**CITY OF SEATTLE  
ANALYSIS AND DECISION OF THE DIRECTOR  
OF THE DEPARTMENT OF PLANNING AND DEVELOPMENT**

**Application Number:** 2307760

**Applicant Name:** Mindy Black & Kristin Scott, Weber + Thompson,  
for Murray Franklyn

**Address of Proposal:** 2205 N. 45<sup>th</sup> St.

**Figure 4.** Concept sketches of the commercial façade and entry to the residential “mews”.

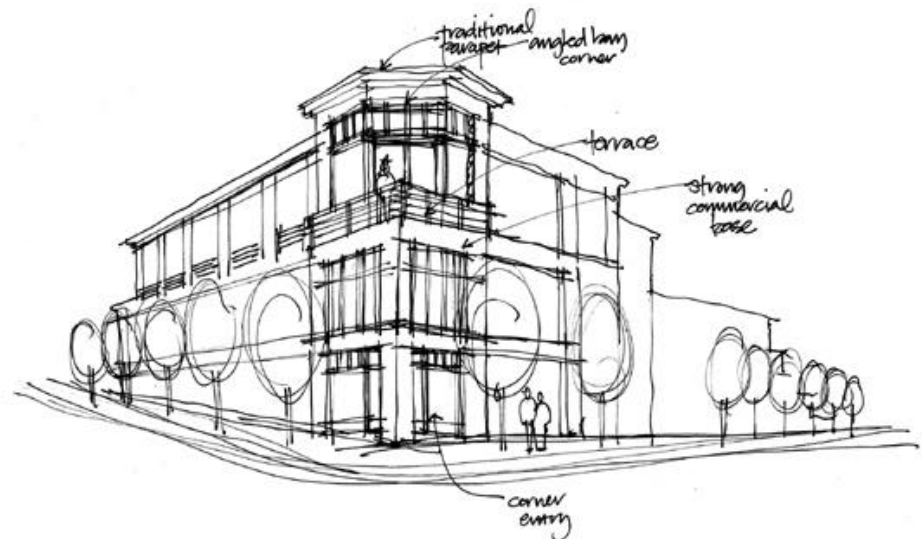
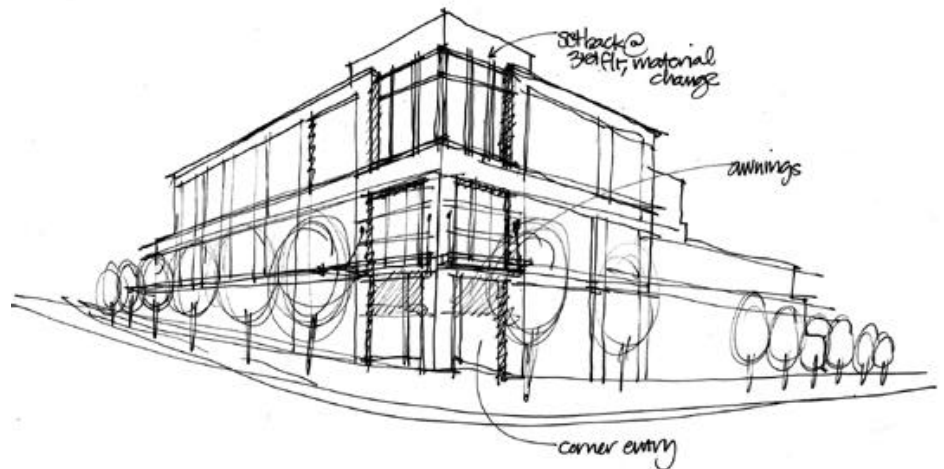
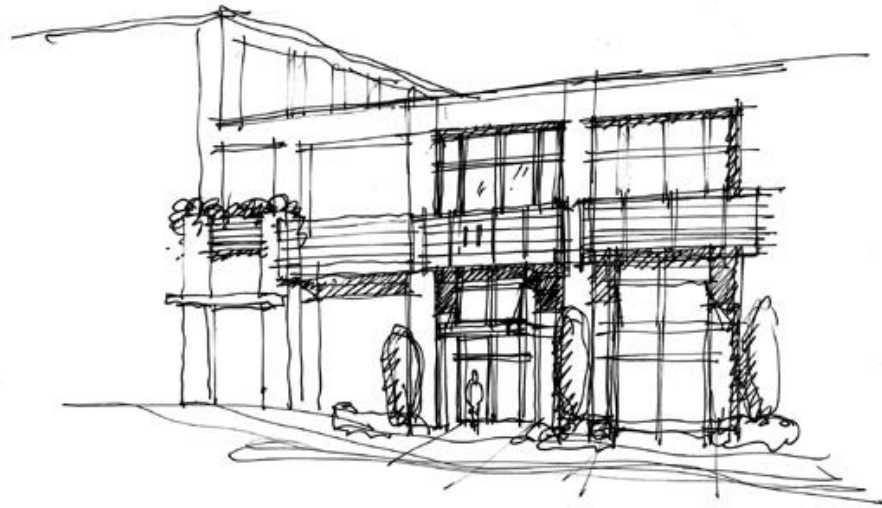
The architect discussed a variety of façade concepts, illustrated above: the northern commercial façade (Figure 4), the northwest corner at 45<sup>th</sup> and Bagley (Figure 5) and the west-facing residential façade (Figure 6). Architects welcomed feedback from the Board and public to refine design priorities. Concept studies experimented with building materials, modulations, and horizontal and vertical expressions of the design's principal lines.

- Congratulate the design team for being so responsive to previous concerns. Various design vignettes show you've put a lot of thought into it.

- Really like the mews concept. Need to carry the portal edge back to Walt's to complete the northeast corner and give it substance.
- I agree with comments at the meeting that the mews entrance elevation should wrap around to the south.
